**SUBJECT: SUBMITTAL OF COMMENTS ON THE FOURTH YEAR OF IMPLEMENTATION OF  
THE REACTOR OVERSIGHT PROCESS THING**

## Comments on the 4<sup>th</sup> Year of the Reactor Oversight Process

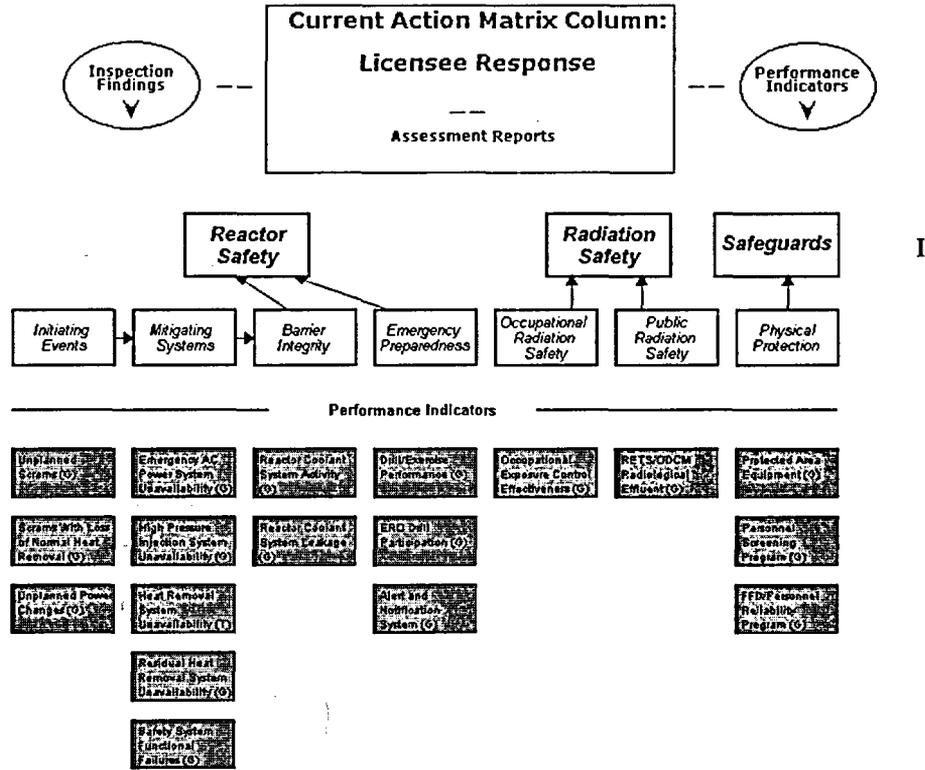
D C Cook Unit 2 suggests the adverse consequences of this current practice. On March 13, 2003, NRC Region III granted enforcement discretion to allow D C Cook Unit 2 to continue operating longer than the LCO time with one of three Auxiliary Feedwater Pumps broken. As shown in the following PI charts, D C Cook Unit 2 already experienced a number of unplanned power changes and had also experienced enough scrams with loss of normal heat removal to cross the GREEN/WHITE threshold. The Unplanned Power Changes PI should have accounted for the March 2003 event, since a shut down would have resulted had not Region III opted not to enforce the terms of the operating license. D C Cook Unit 2 should not get doubly rewarded for Region III's largess.
